South Texas Project Electric Generating Station P.O. Box 289 Wadsworth, Texas 77483

December 21, 2010  
U7-C-STP-NRC-100274

South Texas Project  
Units 3 and 4  
Docket Nos. 52-012 and 52-013  
Supplemental Response to Request for Additional Information

RAI 03.07.01-27, Supplement 1

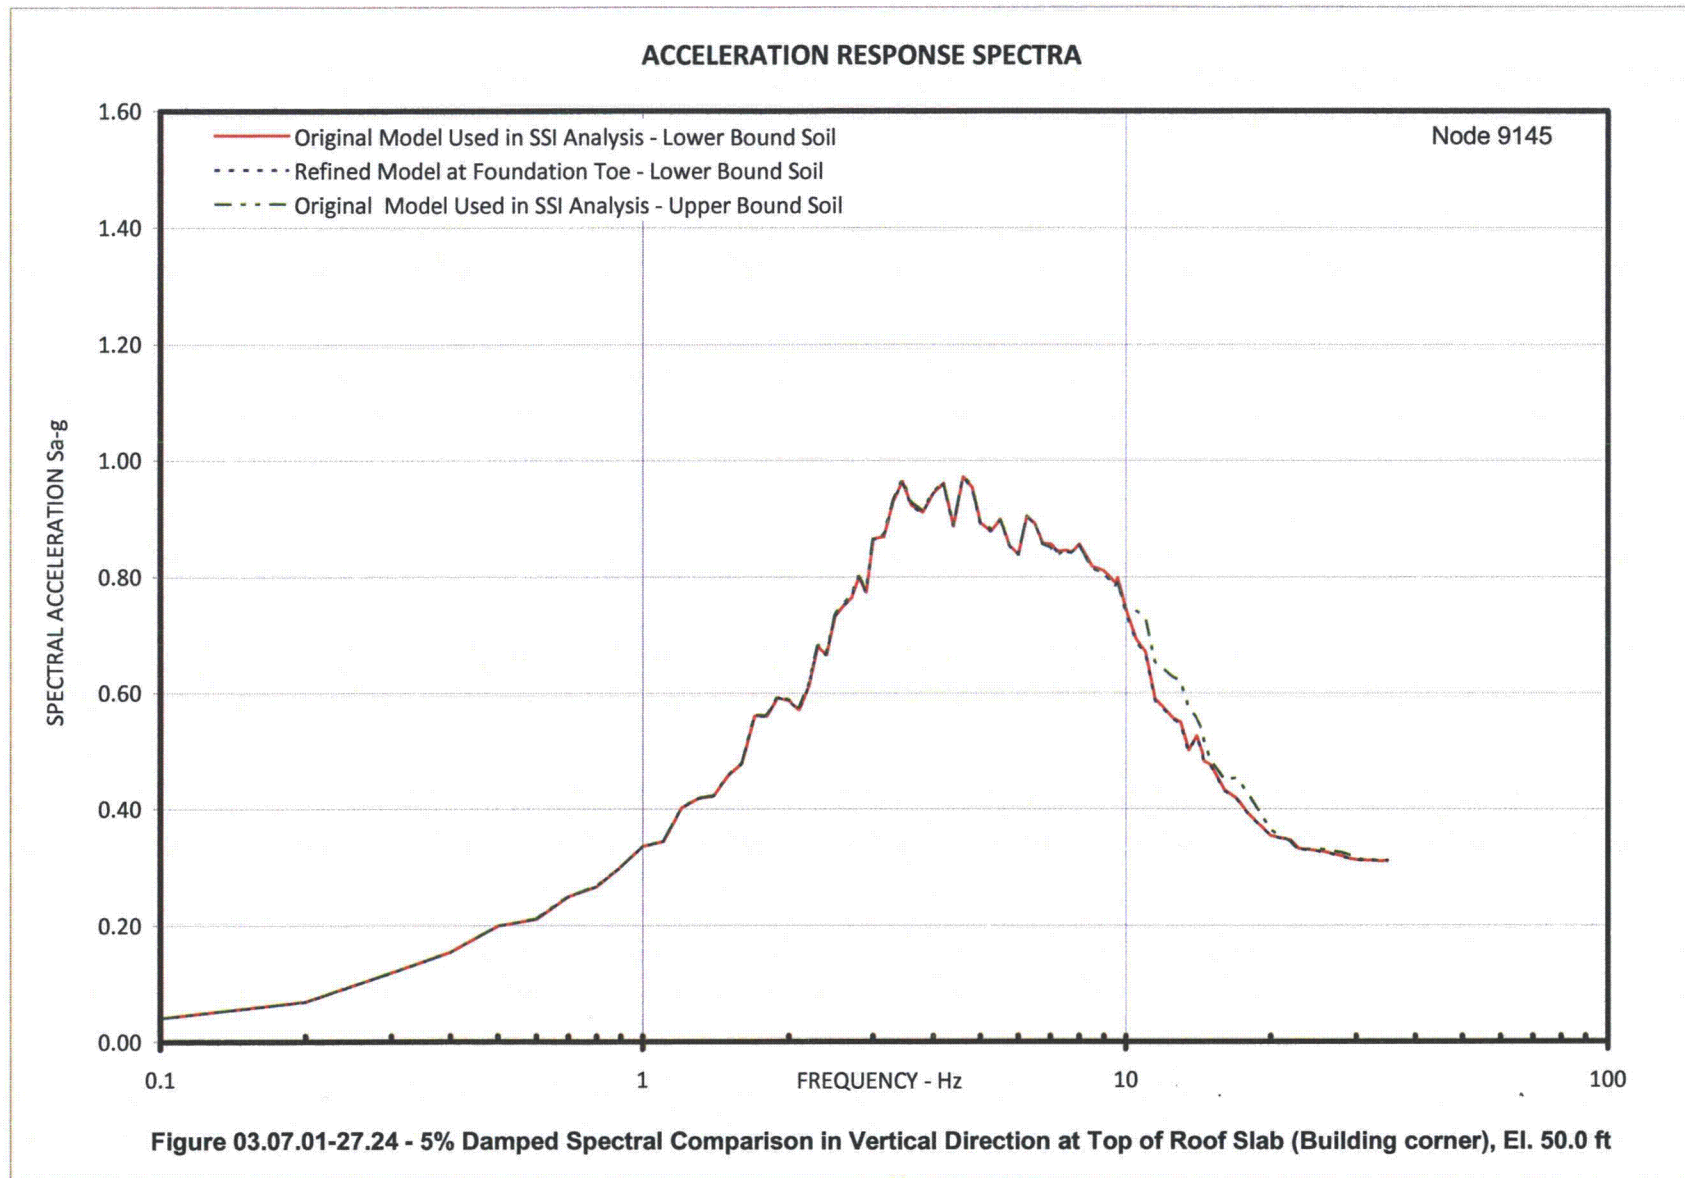
- (a) Describe in detail the method used for the SSI analysis of DGFOVS including the procedures for treatment of strain dependent backfill material properties in the model, input motion used and how it is specified in the analysis, variation of soil properties, and the computer programs used for SSI analysis.

To evaluate the effect of 20 Hz passing frequency for LB in-situ case, the foundation toe was divided into two elements, thus increasing the passing frequency to 40 Hz. This refined model with LB in-situ soil properties was analyzed and 5% damped spectra from this model were compared with the spectra from the original model with passing frequency of 20 Hz. The spectra comparison plots are shown in Figures 03.07.01-27.1 through 03.07.01-27.24. The comparison shows that:

- In the X direction, there is insignificant difference between the response spectra from the two models
- In the Y direction, the response spectra from the two models matched well except at frequency of about 3.8 Hz where the refined model produced higher spectra. However, spectra from both the models are enveloped by the spectra for UB in-situ soil case
- In the vertical direction, the spectra from the two models matched well (insignificant difference)

Based on the above evaluation it is concluded that the horizontal direction passing frequencies are acceptable.

**Figure 03.07.01-27.25: Comparison of Horizontal Response Spectra at DGFOV 1A Basemat Top**

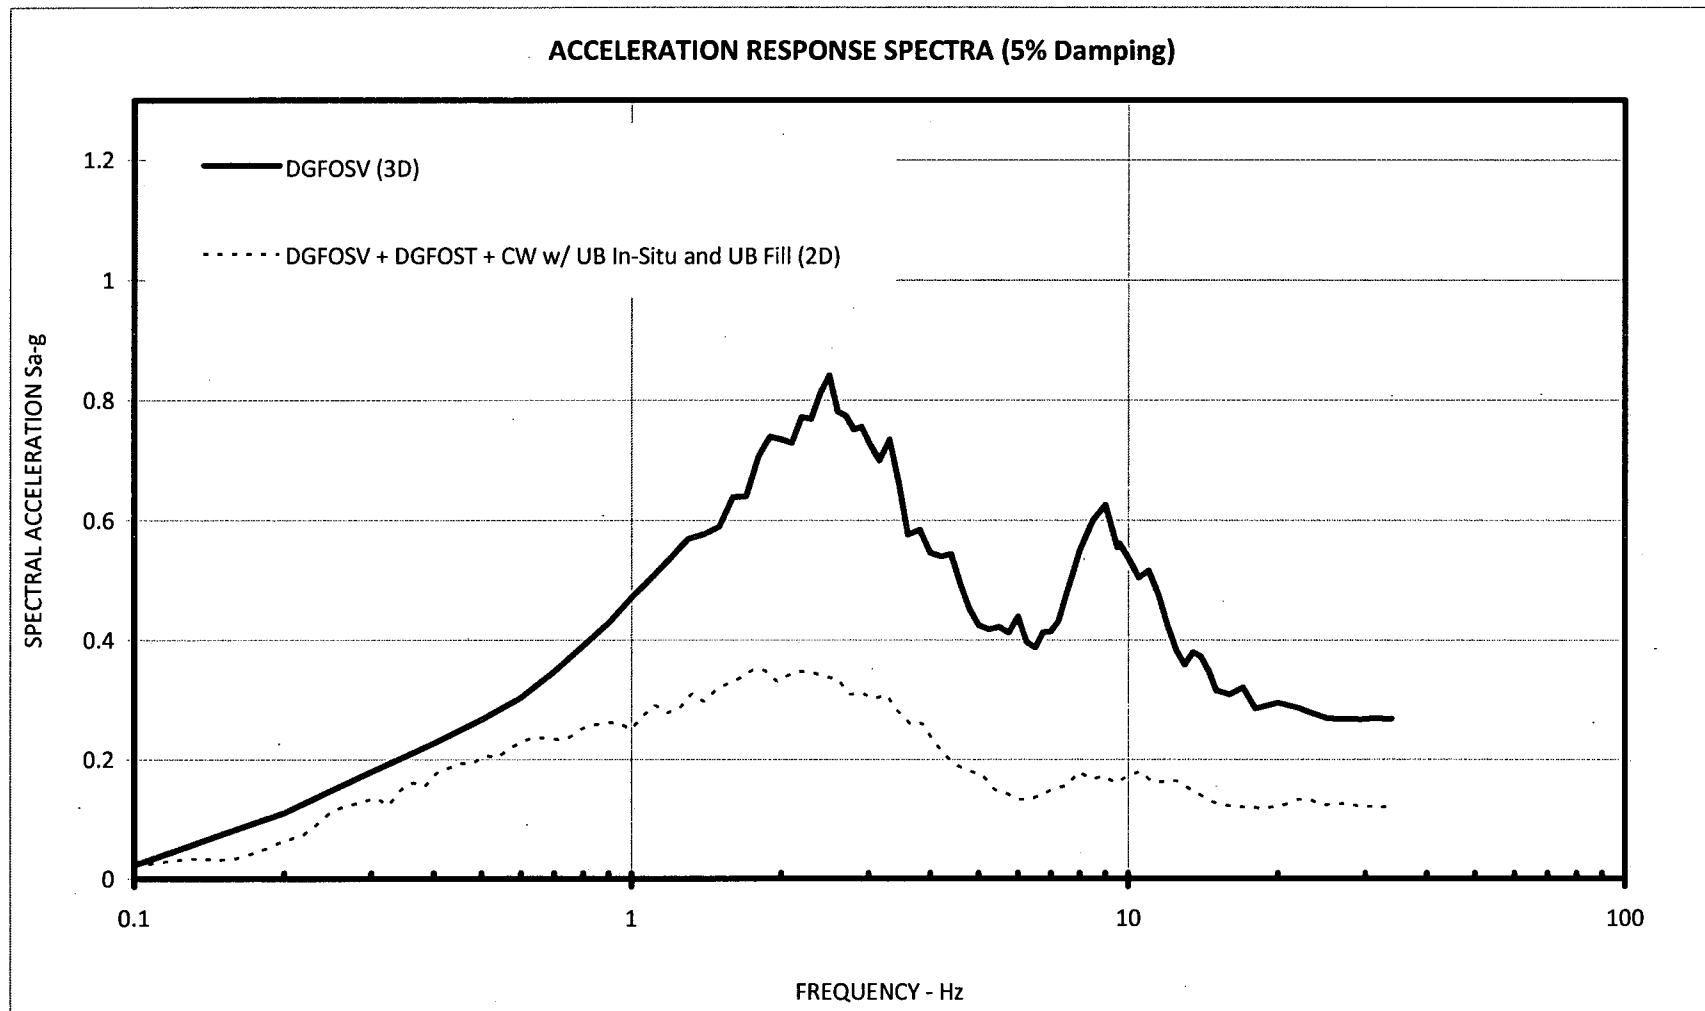
- (c) Demonstrate that the DGFOVS foundation response spectra and dynamic soil pressure (on DGFOVS basement walls using ASCE 4-98 criteria) used in the design of DGFOVS will envelop the results of structure to structure (SSSI) interaction analysis which explicitly models DGFOVS structure in the SSI model of RB and the RSW Pump House structure.

Figures 03.07.01-27.25, 03.07.01-27.26 and 03.07.01-27.27 show the comparisons between the DGFOV foundation level 5% damped response spectra obtained from the

3D SSI analysis (enveloped for all soil cases and used for the design of the DGFOSV) and the 5% damped foundation spectra obtained from 2D SSSI analyses. The comparisons show that the design spectra obtained from the 3D SSI analyses envelop the spectra obtained from the 2D SSSI analyses. Note that the input motion for the 3D SSI analysis corresponds to 0.3g Regulatory Guide 1.60 spectra, and the input motion for 2D SSSI analysis is the site specific SSE.
